Vermont Agency of Transportation  
**RECEIVED**  
 CK'D BY NAVAG OK'D BY JS  
 March 24, 2015  
 RESUBMIT YES Rejected  
 BY KH DATE 3-30-2015

**- 91 NB LEFT LANE CLOSURE (BARRIER)**

PROJECT NAME: HARTFORD  
 PROJECT NUMBER: IM 091-2(79)  
 FILE NAME: sl2a026\_NB Left Closure.dgn  
 PROJECT LEADER: K. HIGGINS  
 DESIGNED BY: B. LYON  
 I-91NB LEFT LANE CLOSURE (BARRIER)  
 PLOT DATE: 03/24/15  
 DRAWN BY: B. LYON  
 CHECKED BY: S. SAWYER  
 SHEET 42 OF ??

I-91 NB LEFT LANE CLOSURE (BARRIER)

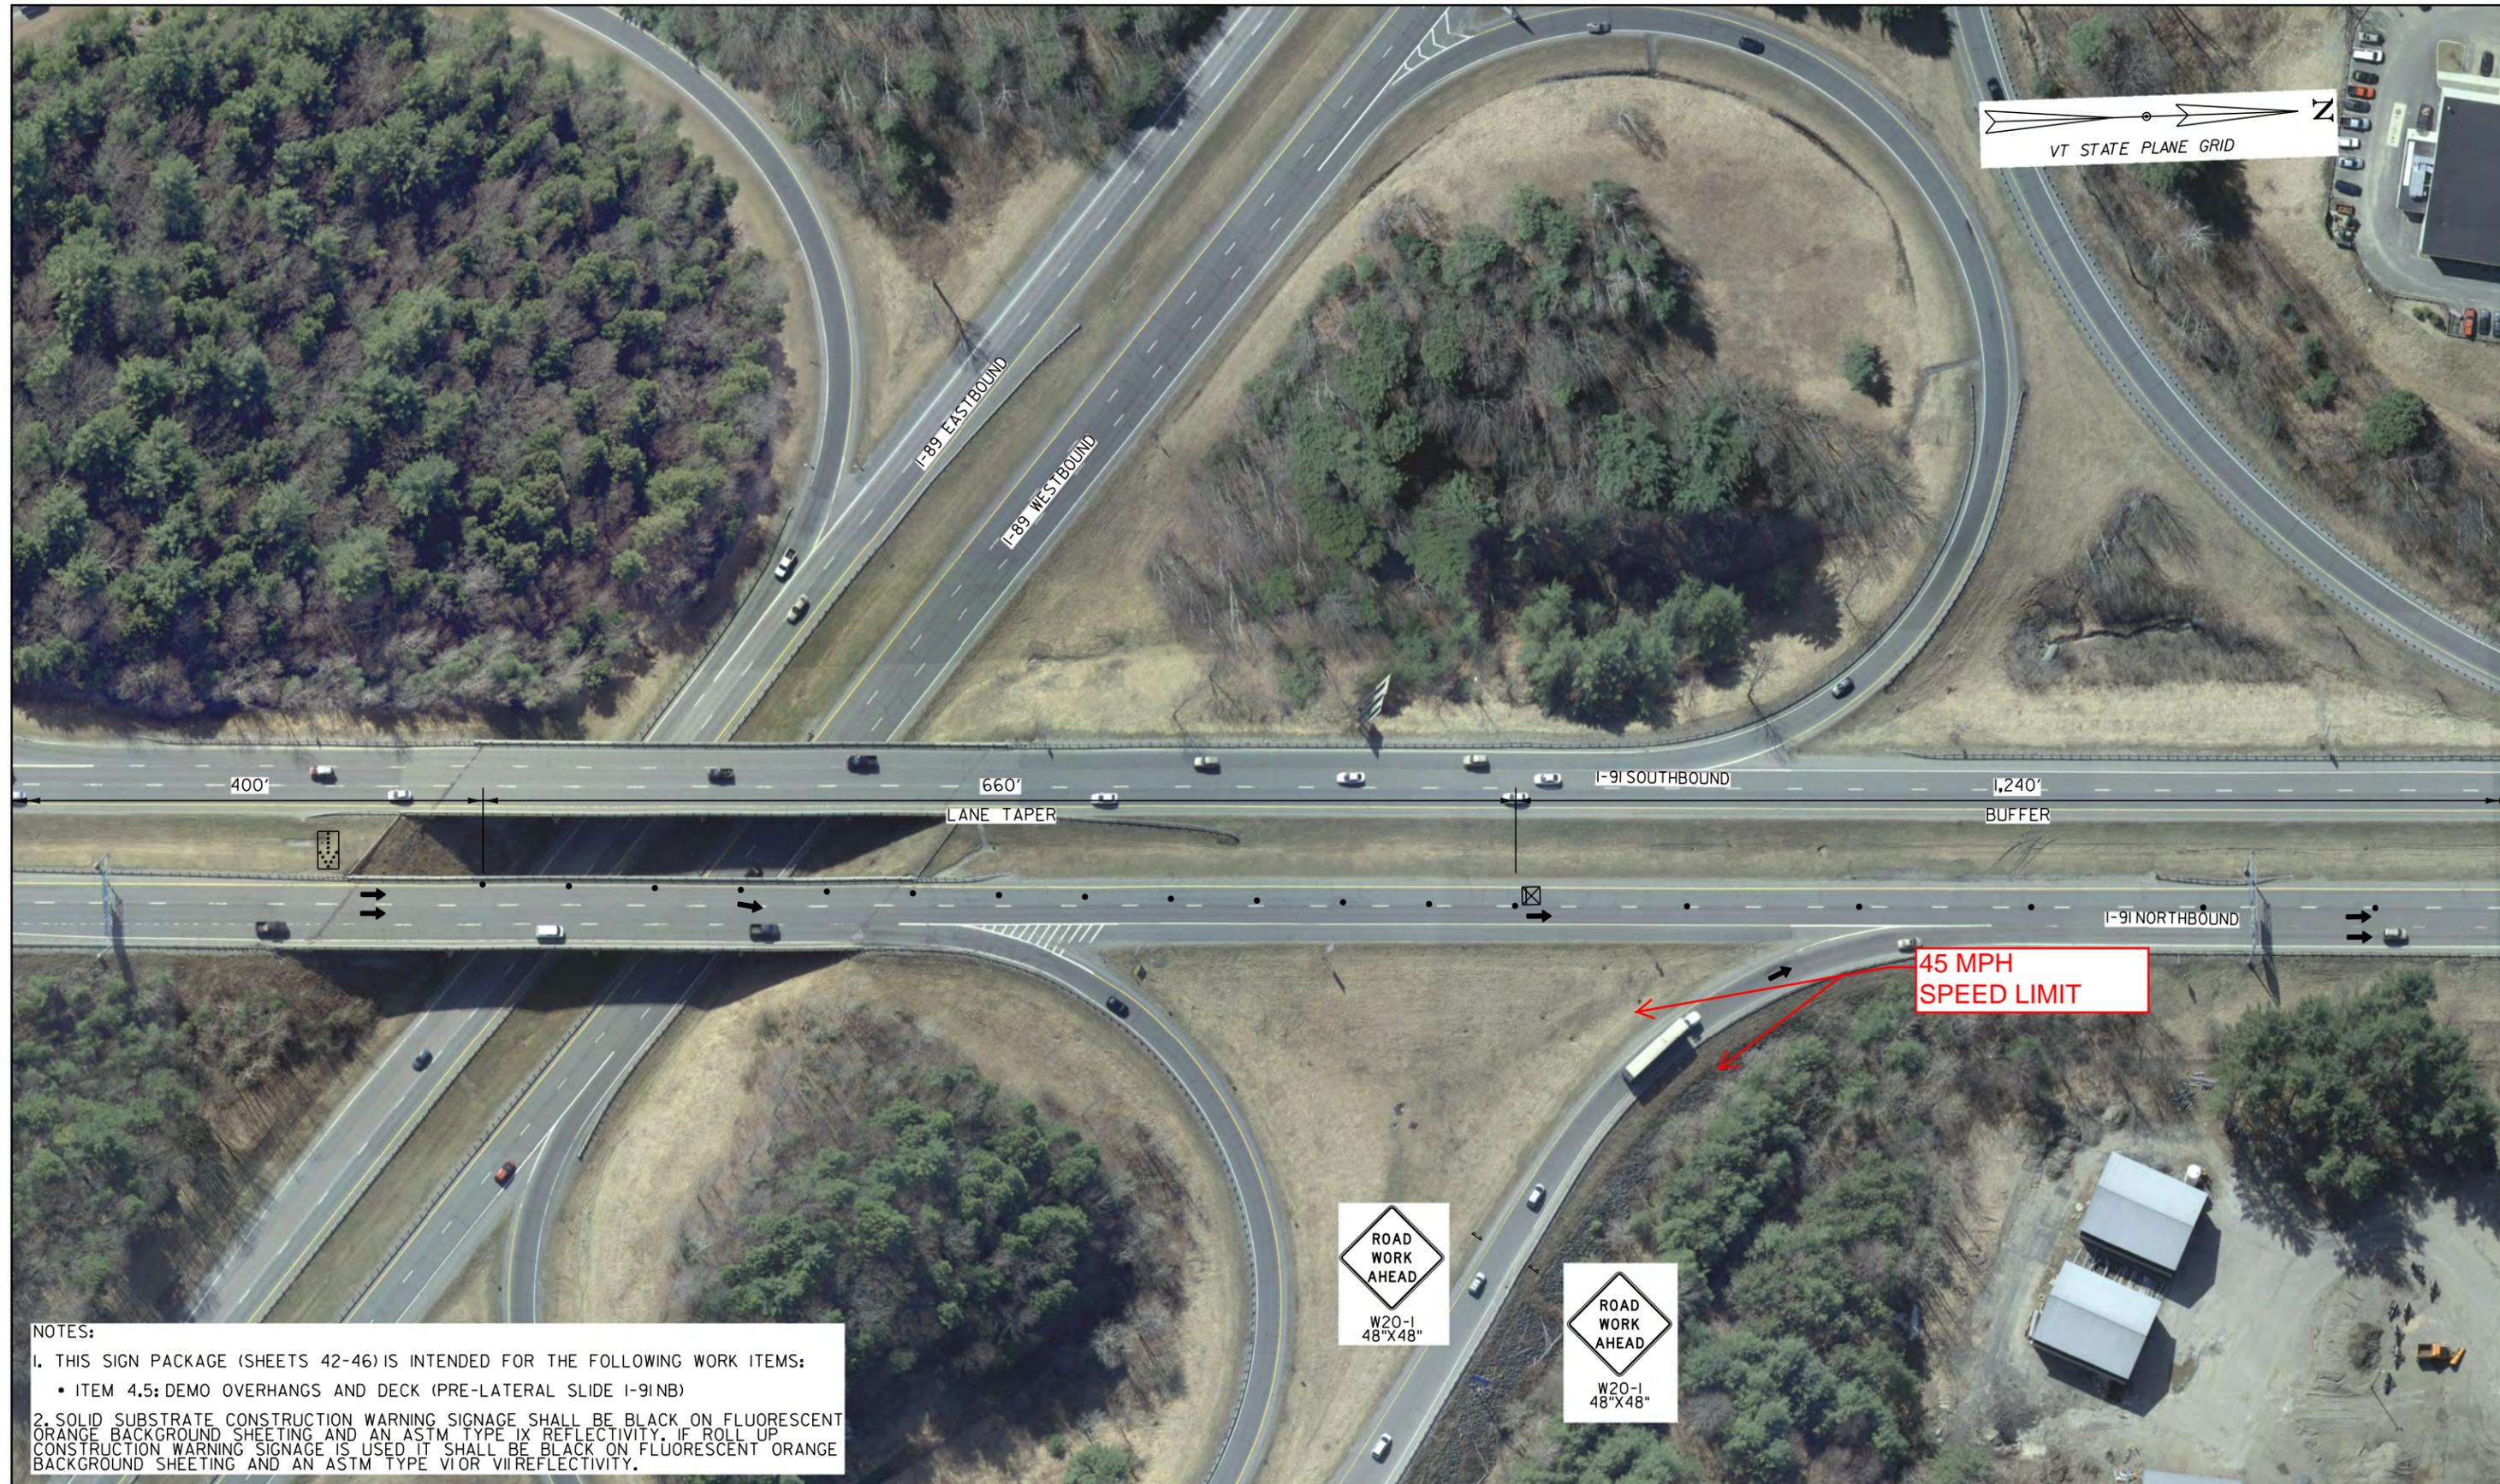
The VR-355 can be omitted if an R2-6aP "FINES DOUBLE" plaque is added to the bottom of the speed limit assembly (G20-5aP + R2-1)

PROJECT NAME: HARTFORD		PLOT DATE: 03/24/15	
PROJECT NUMBER: IM 091-2(79)		DRAWN BY: B. LYON	
FILE NAME: sl2a026_NB Left Closure.dgn	DESIGNED BY: B. LYON	CHECKED BY: S. SAWYER	SHEET 44 OF ??
I-91NB LEFT LANE CLOSURE (BARRIER)

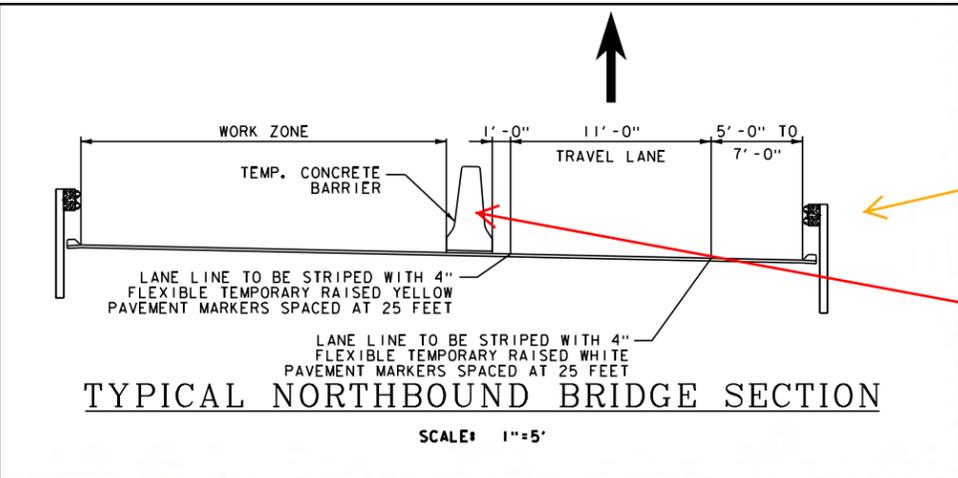
see standard T-13 for RPMs and temp markings. If existing lines are conflicting, they need to be masked.

PROVIDE CONNECTION DETAILS

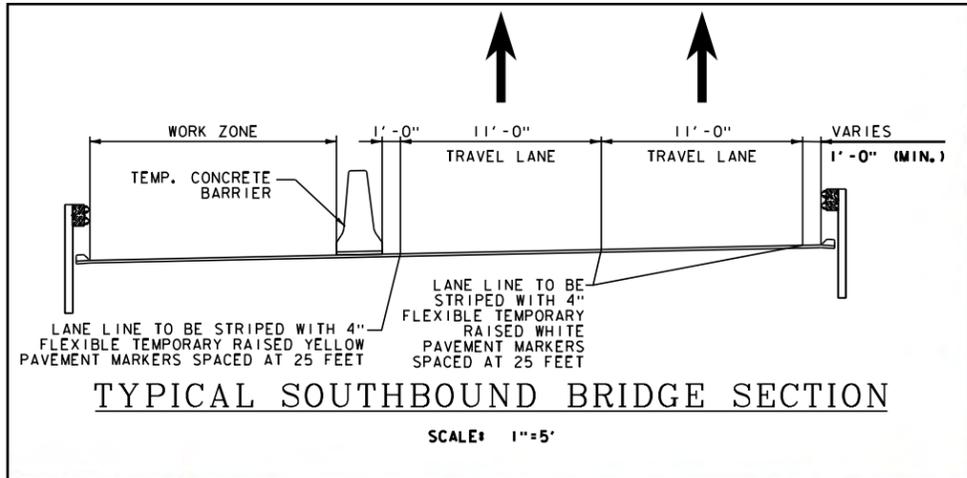
If L=660 than  
the should  
tapper =  
 $660/3=220ft$
